## Product Change Notification / RMES-02XQHS264

CCB 3658.006 Final Notice: Qualification of MPHL as an additional final test site for selected ATSAML21G1xB device family available in 48L VQFN (7x7x0.9mm) package.

**CCB 3658.006**  
**Pre and Post Change Summary**  
**PCN #: RMES-02XQHS264**

# Pre and Post Change Summary

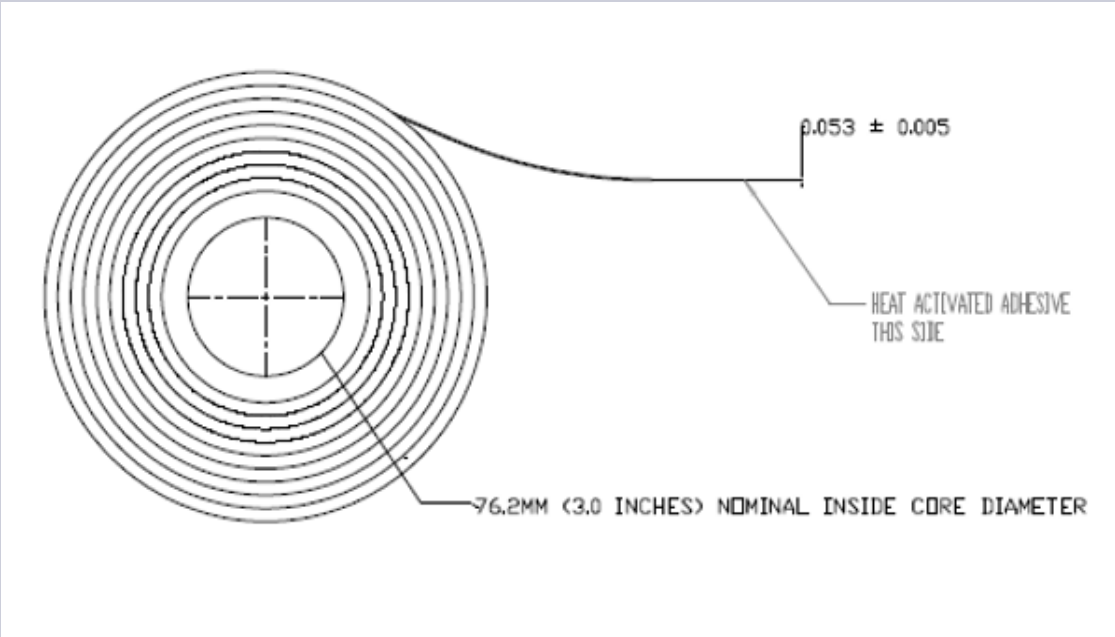
ASE9	MPHL
<b>Final Test Location</b>		ASE Test (ASE9)	Microchip Technology Operations (Philippines) Corporation (MPHL)
<b>Base Quantity Multiple (BQM)</b>	<b>Tape and Reel</b>	4000 units per reel - No changes	
<b>Pin 1 Orientation</b>		Quadrant 1 – No changes

# Pre and Post Change Summary – Cover Tape

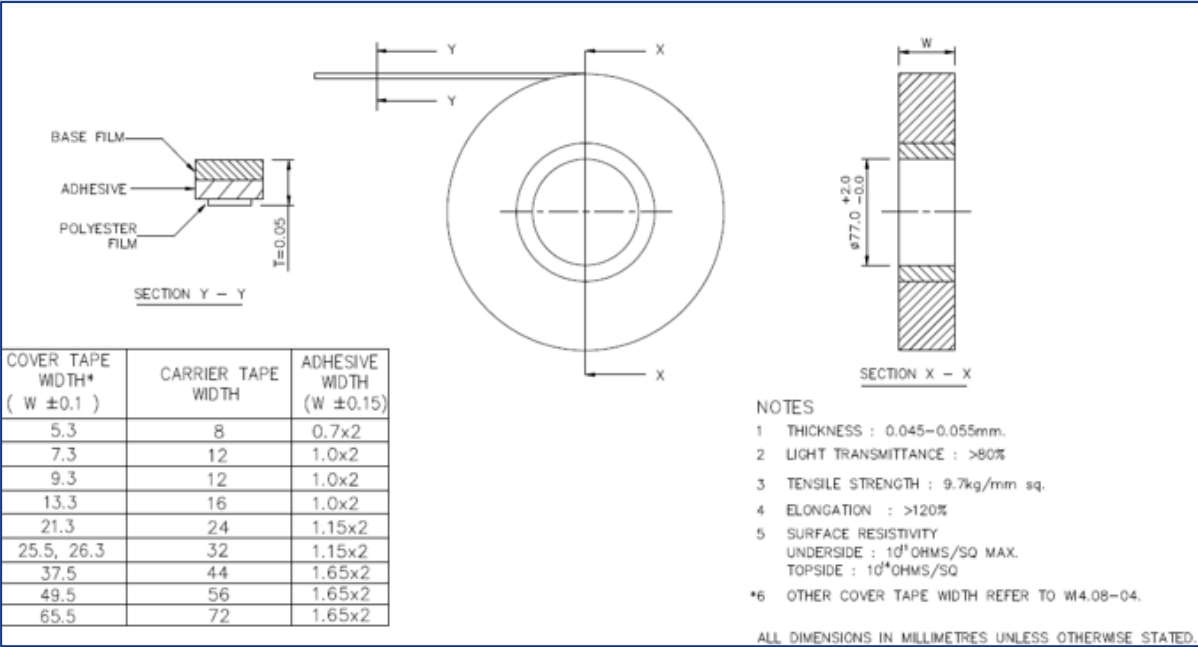
Cover tape color	Width $\pm 0.1$ (mm)	Thickness $\pm 0.005$ (mm)	Sealing Methodology
Clear	13.3 mm	0.053+/-0.005	Heat Seal

Cover tape color	Width $\pm 0.1$ (mm)	Thickness $\pm 0.005$ (mm)	Sealing Methodology
Clear	13.3 mm	0.050	Pressure Seal Activated
